# SITE DEVELOPMENT PLAN FOR WALDEN SANITATION DISTRICT WASTEWATER TREATMENT PLANT PROJECT EL PASO COUNTY, COLORADO MARCH 2026

SHEET TITLE: SITE DEVELOPMENT PLAN		
PROJECT NUMBER: PCD FILE PPR2538	SCALE: 1" = 80'	SHEET: C1.2

# V3\_ Site Dev Plan.pdf Markup Summary

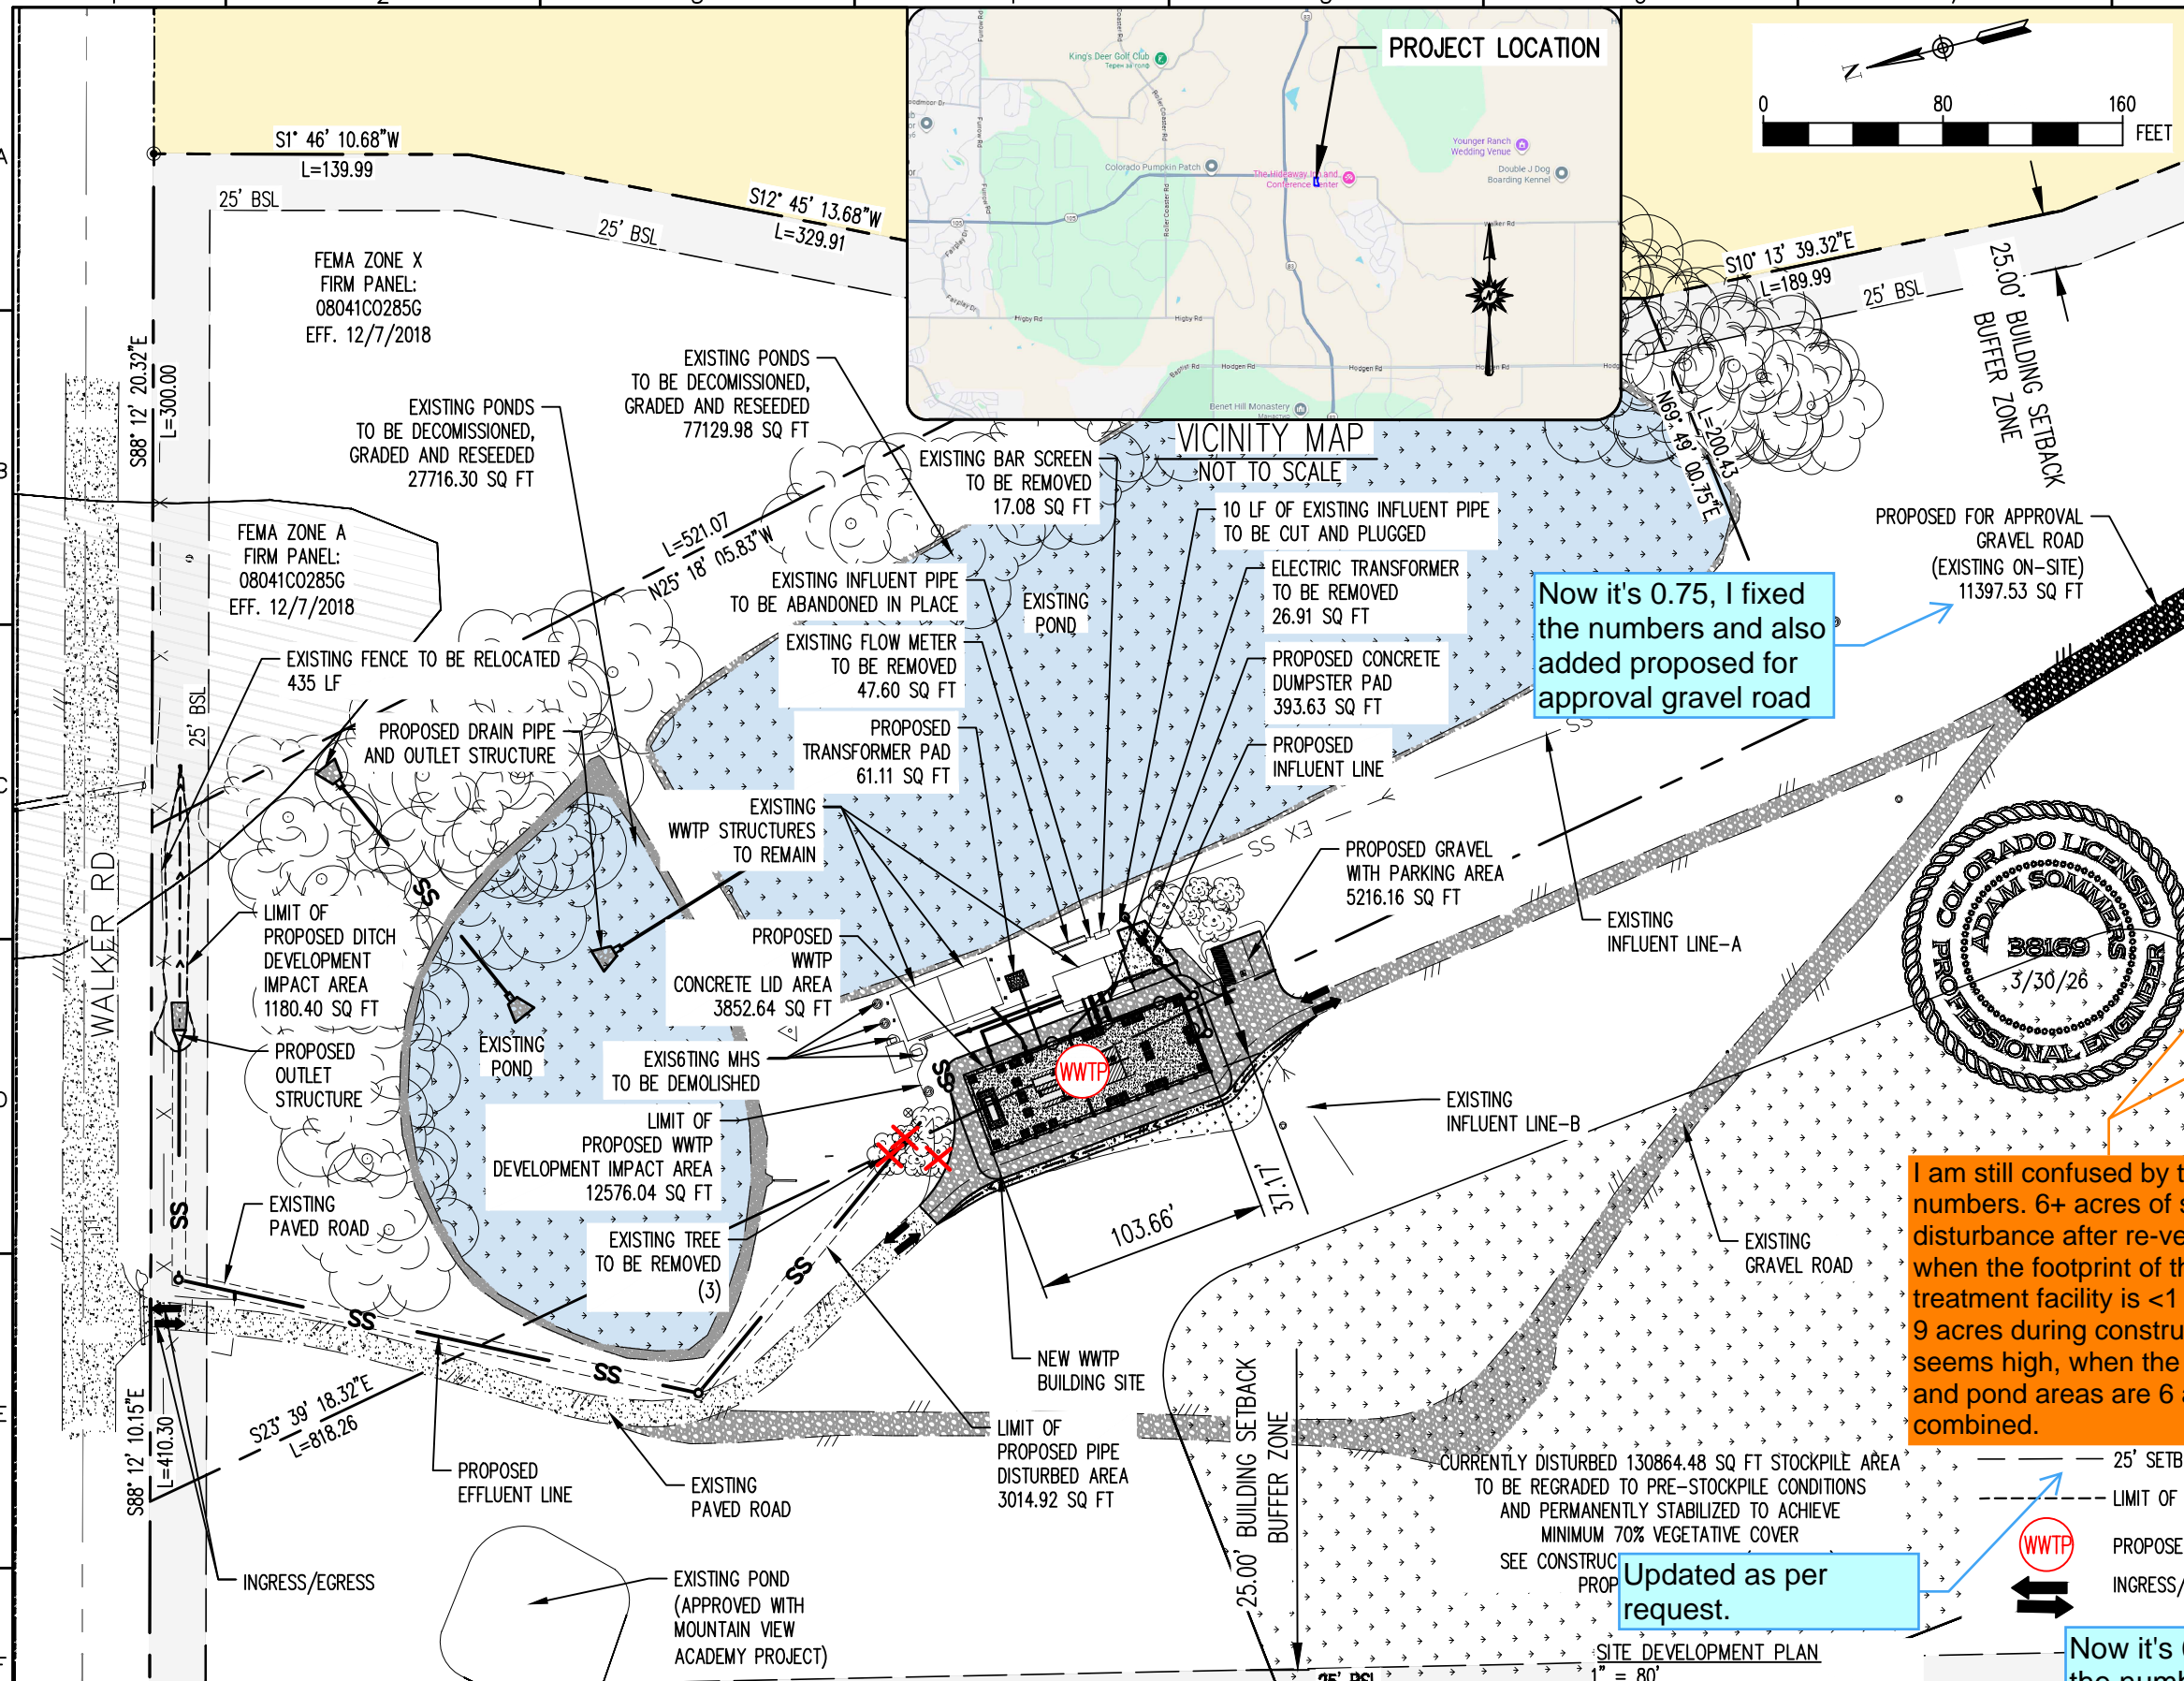
I am still confused by these numbers. 6+ acres of soil disturbance after re-vegetation when the footprint of the new treatment facility is <1 acre. And 9 acres during construction seems high, when the stockpile and pond areas are 6 acres combined.

Areas do not match.

0.54 ac per previous sheet?

Updated as per request.

Now it's 0.75, I fixed the numbers and also added proposed for approval gravel road
